Groundwater & Wastewater Services
Septic Project File & Data Review Worksheet

IMPROVEMENT PERMIT for a RESIDENTIAL ON-SITE WASTEWATER TREATMENT & DISPOSAL SYSTEM

GWS Septic System Design Review

RE: Request for an Improvement Permit for Lot 25 off of Sample Road.
MCHD File #6763B

ENCASEMENT PIPE DETAIL

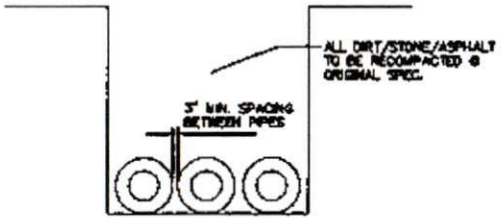
Mr. Fox-
Retreat at Latta specifically. I know NCDOT is much more reasonable, so I was wondering if we could do something a little less than welded steel pipe that may actually last longer. Welded Steel piping painted is $150K more than ductile iron with slip joints and tracer wires, and I cannot imagine there is a structural difference to the roadway. I would really like some help with that if you can.

Mr. Fox-
I was wondering if there is an alternate to the standard crossing detail or if we could propose an alternate to the welded steel pipe required by Huntersville. This is an extremely expensive option, and we would like to propose using ductile iron pipe with slip joints and different color tracer wires. We would still as-built everything the same, but the cost savings is tremendous, and the different color tracer wires would last longer than paint. Can you approve or is there someone else I'd need to go through?
Thanks,
Tom

Upon your request, you may use slip joint ductile iron encasement pipe in lieu of the welded steel pipe as indicated on the Encasement Detail for the low pressure sewer crossings at the Retreat at Latta. This change is being made due to the fact that ductile iron will provide adequate strength for the crossing as well as provide water tight seals at the joints. Please note however, this is the only change being made to that detail. Specified lengths, depths, and sizes shall still be in compliance with the detail.
